Proposal for Corrigendum 1 to global technical regulation No. 11 (Non-Road Mobile Machinery (NRMM))

Submitted by the Working Party on Pollution and Energy*

The text reproduced below was adopted by the Working Party on Pollution and Energy (GRPE) at its sixty-first session to introduce a number of editorial corrections to the current text of the global technical regulation No. 11. It is based on ECE/TRANS/WP.29/GRPE/2011/2, not amended (ECE/TRANS/WP.29/GRPR/61, para. 19). It is submitted to the World Forum for Harmonization of Vehicle Regulations (WP.29) and to the Executive Committee (AC.3) for consideration.

Figure 7.3
Test sequence

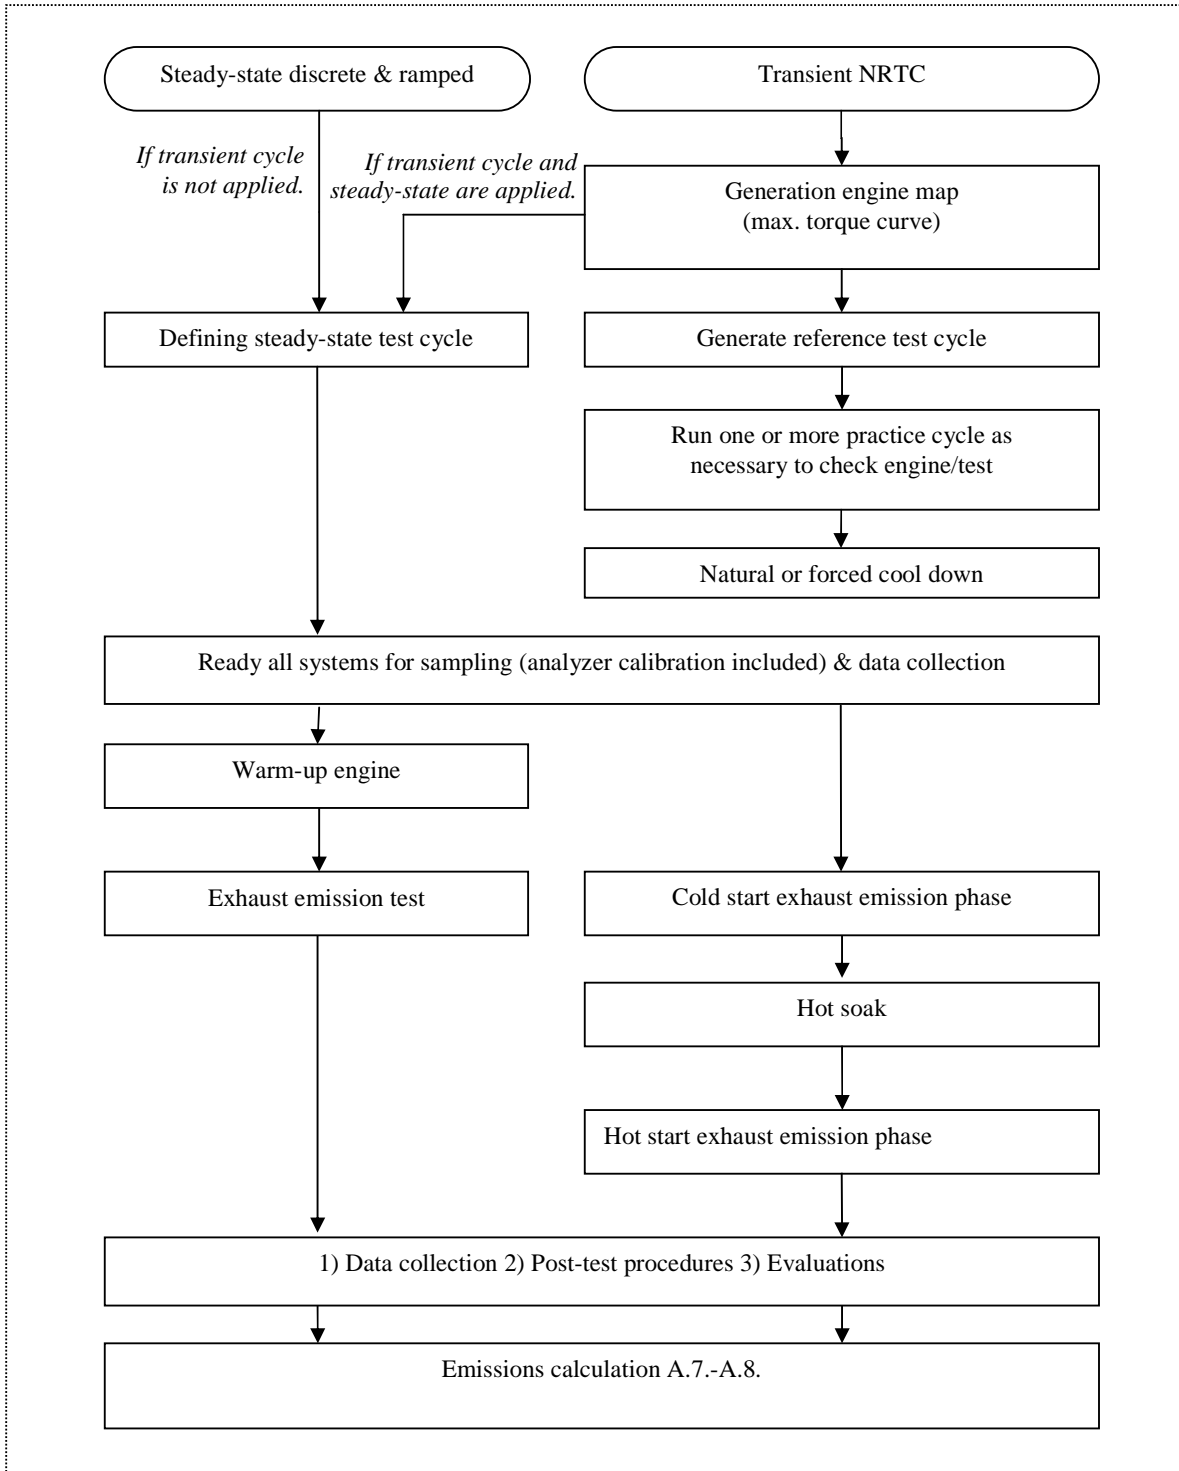
Paragraph 7.5., amend to read:

The following diagram gives an overview about the procedures needed to conduct NRMM test cycles with measuring exhaust engine emissions.

"Figure 8.1

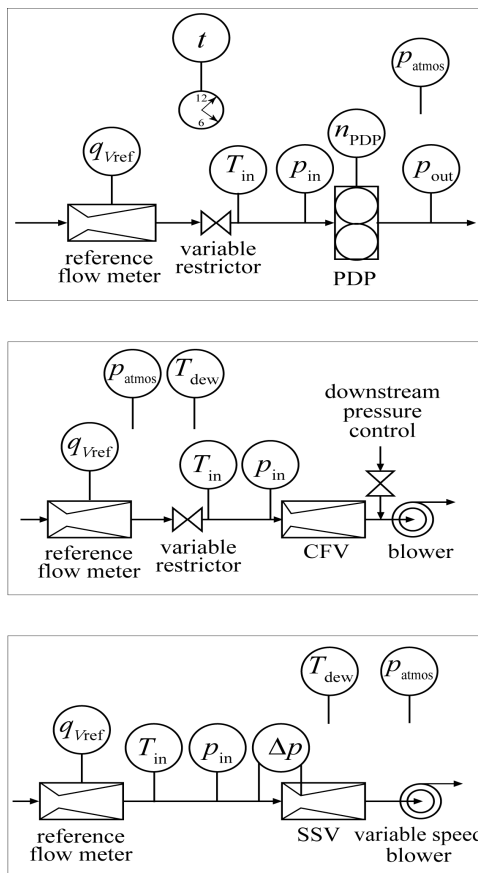
Paragraph 8.1.8.4., figure 8.1, amend to read:

Figure A.4.1

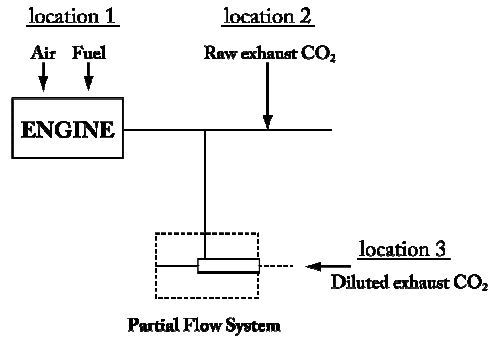
Paragraph A.4.1., amend to read:

Figure A.4.1 shows the sampling points at which the carbon flows shall be checked. The specific equations for the carbon flows at each of the sample points are given in the following paragraphs.

Figure 7.3
Test sequence

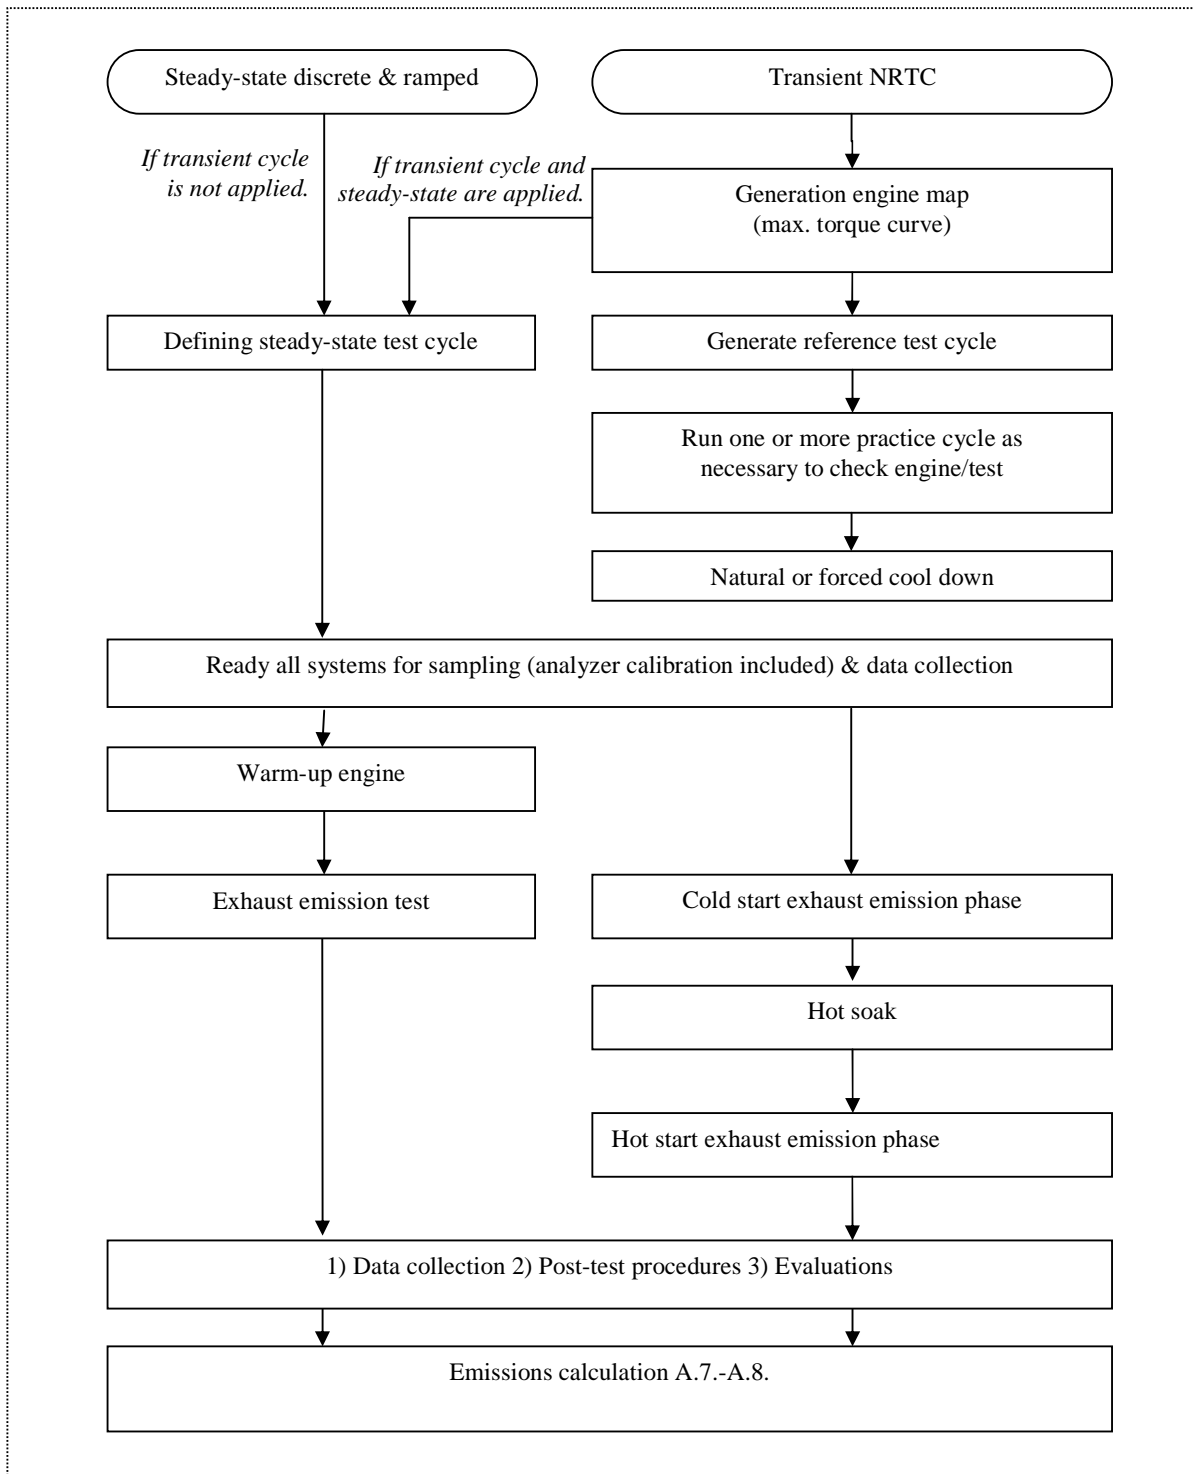
The following diagram gives an overview about the procedures needed to conduct NRMM test cycles with measuring exhaust engine emissions.

"Figure 8.1

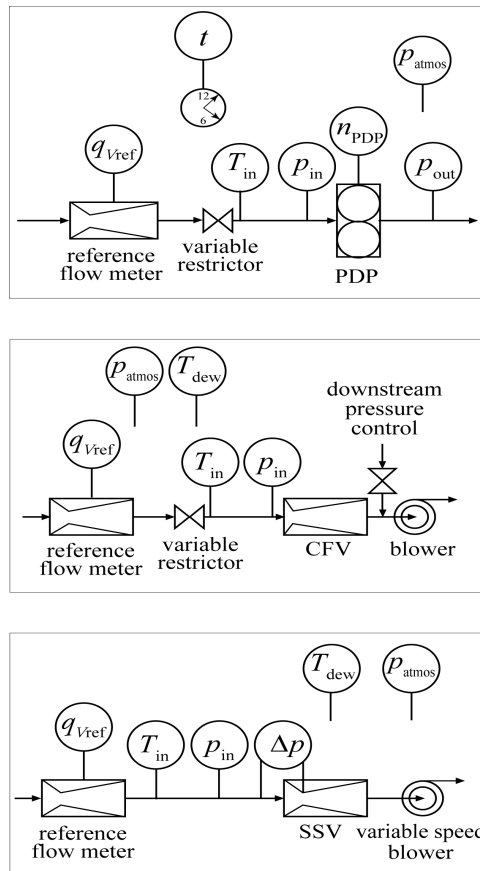
Paragraph 8.1.8.4., figure 8.1, amend to read:

Figure A.4.1
Measuring points for carbon flow check

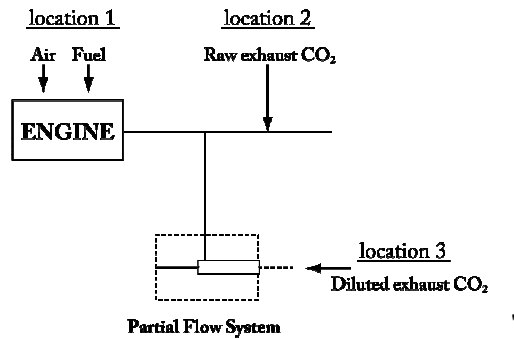
Figure A.4.1 shows the sampling points at which the carbon flows shall be checked. The specific equations for the carbon flows at each of the sample points are given in the following paragraphs.
